71D CRYO - VI7.1 / VI7.2 FITTINGS

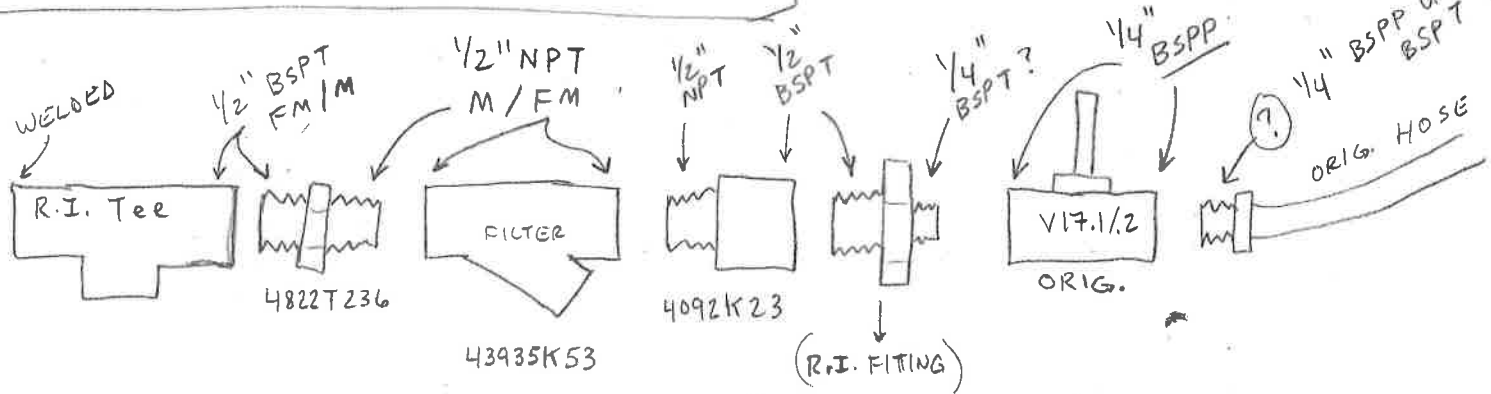
DEC. 2021 →

2-1-21 →

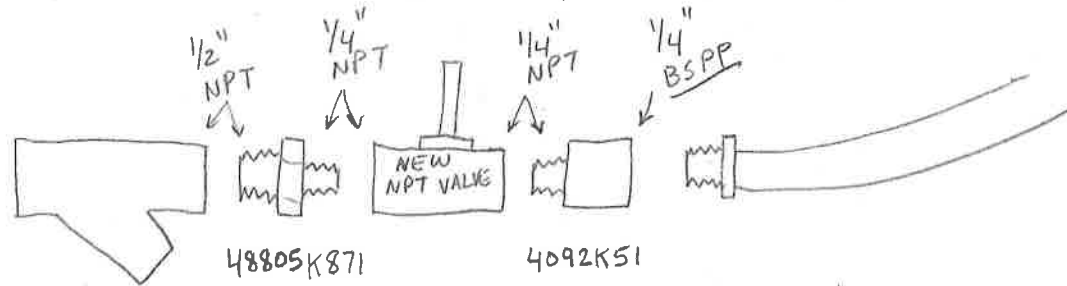
(IF REPLACING WITH ENGLISH NPT SOLENOID)

2-1-21 →

(IF REPLACING WITH BRITISH BSPP SOLENOID)

= SIMPLY SWAP OUT THE ORIGINAL ...

⊗ NOTE ABOUT BRITISH THREADS = BSPT (MALE TAPERED) CAN MATE W/ BSPP (FEMALE PARALLEL)

BSPP CAN NOT MATE W/ BSPT-FM ...
MALE

- BUT ALL BSPP NEED A SEALANT! ...
